CharIN – Charging Interface Initiative e. V.

34th GC ESC meeting

# CharIN evaluation of ACER reactions on CharIN comments in public consultation

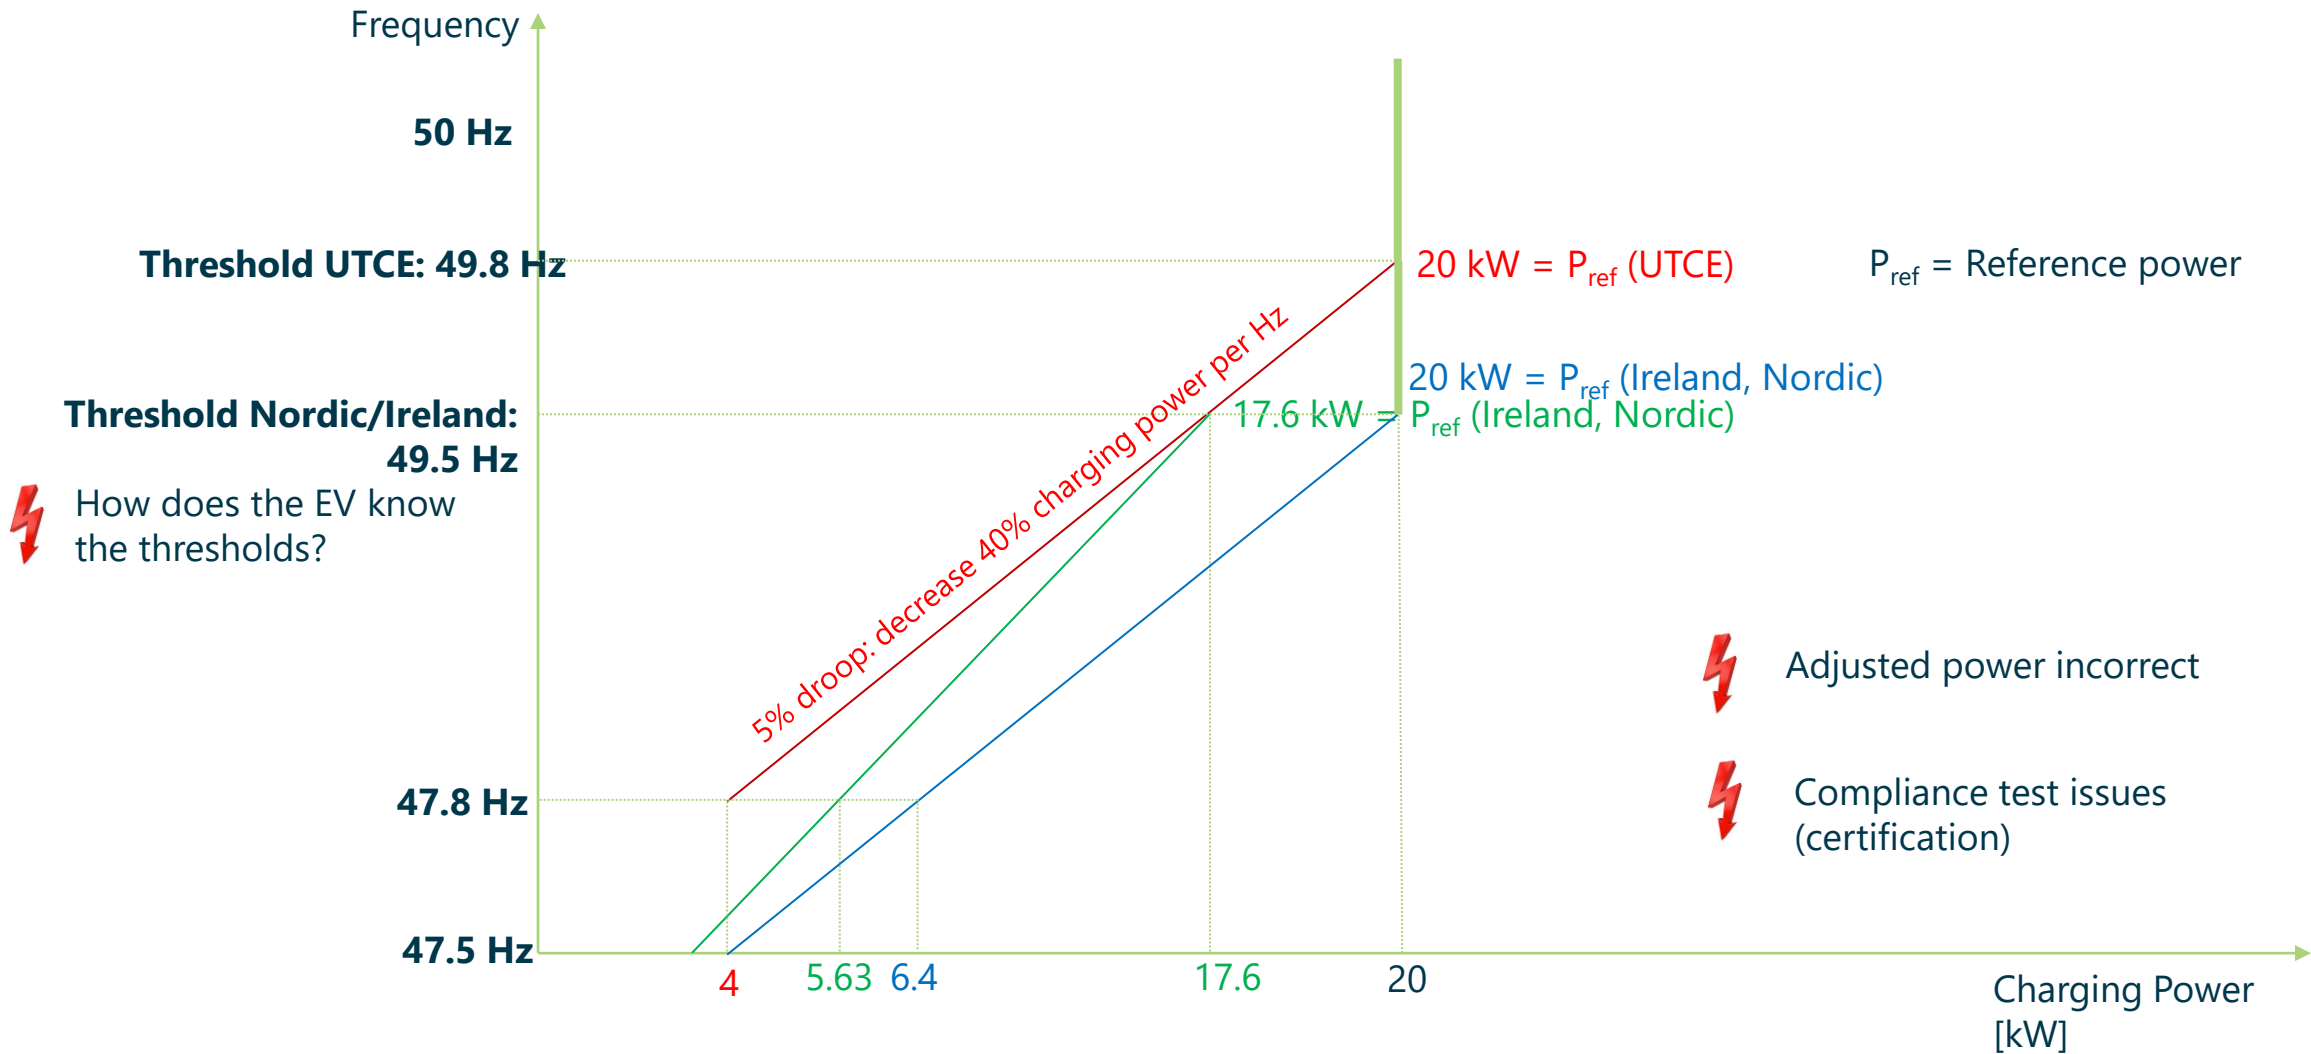
**Why was synchronous area Nordic included in NC DC for 49.5 Hz threshold in NC DC, but not in NC RfG?**

**Different thresholds are difficult to handle for moving EVs!**

**Proposal to harmonize threshold to 49.8 Hz only in whole Europe for NC DC and NC RfG!**

# LFSM-UC: Possible ways of implementation for AC charging – considering mobile EVSE

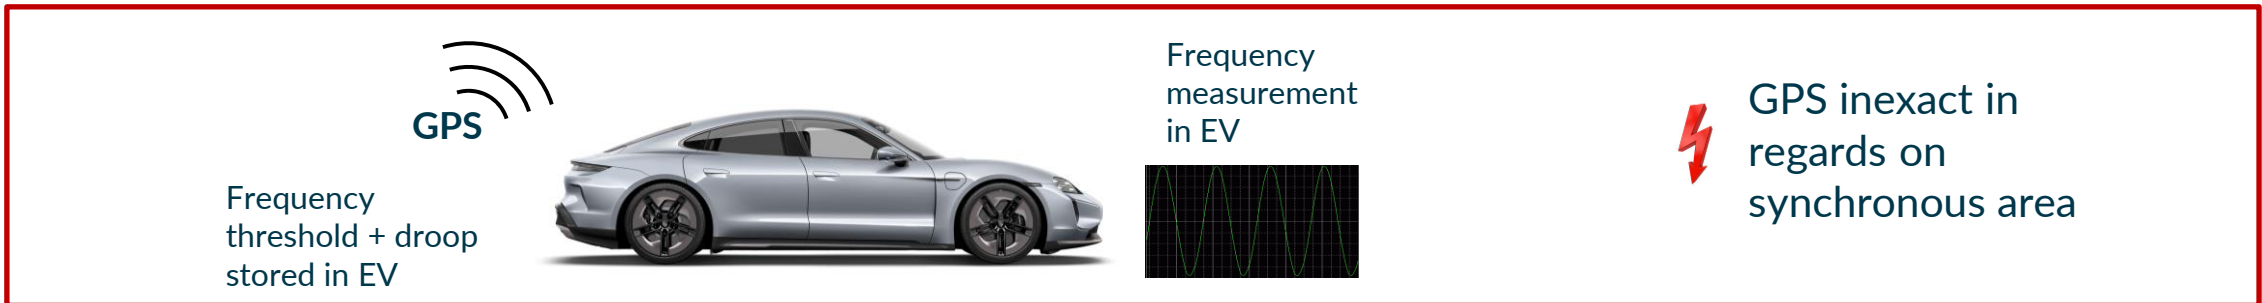
→ Harmonize thresholds!

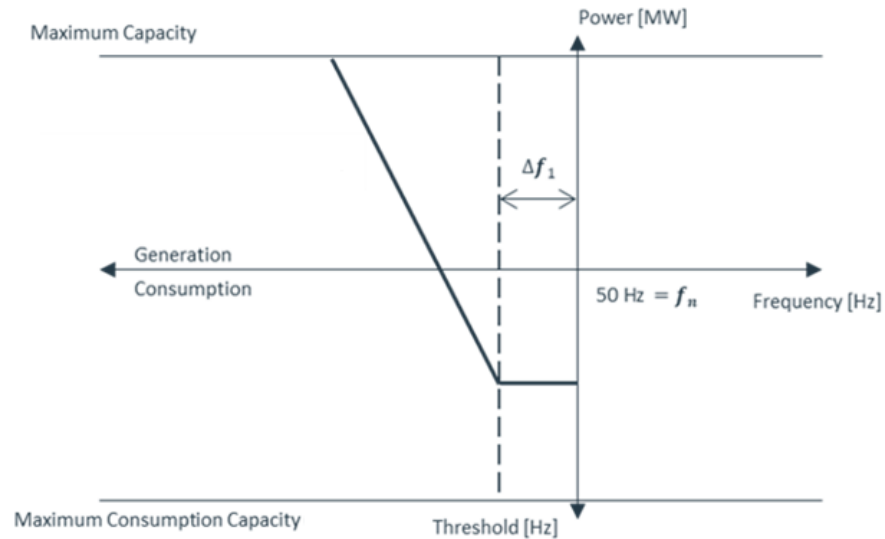
Is this definition correct (NC RfG)?

P<sub>ref</sub> is the **actual active power** at the moment the LFSM-U threshold is reached.

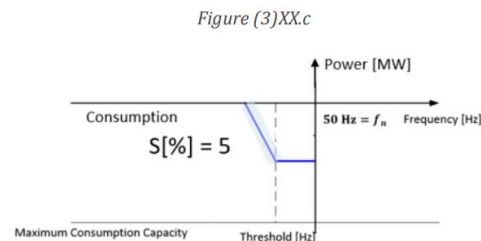
... compared to NC DC:

P<sub>ref</sub> is the actual active power at the moment the LFSM-UC threshold is reached.
